11 September 2026

Minor Change to Development Approval at 25 Harcourt Street, New Farm (Council Ref: A006752507)

Figure 11 – Comparison of Levels 2 and 3 Floorplans

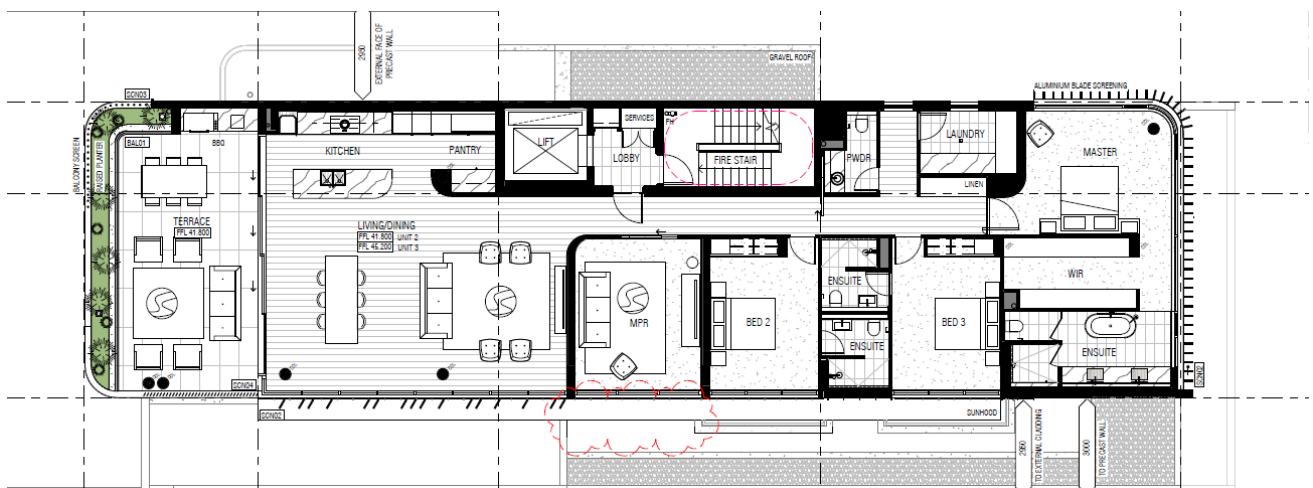
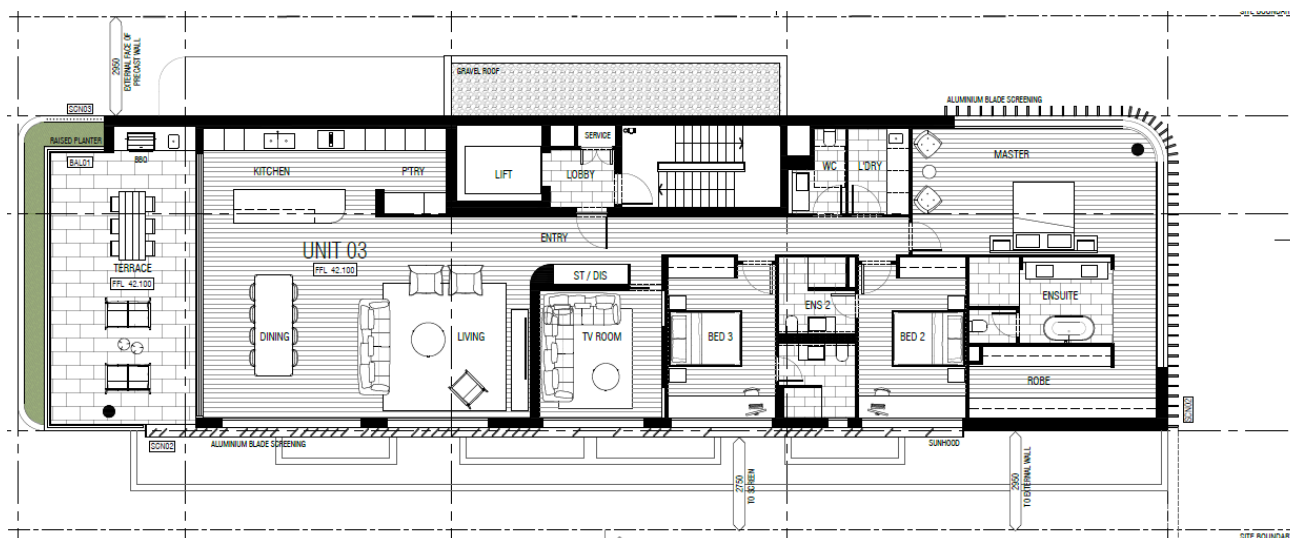
- Refinement to the master suite bedroom, walk-in robe and ensuite configuration located in the eastern portion of the apartment to enhance functionality and efficiency of the space;
- Refinement of the multi-purpose room layout with the addition of hallway storage cupboards; and
- Rearrangement of the powder room and laundry configuration.
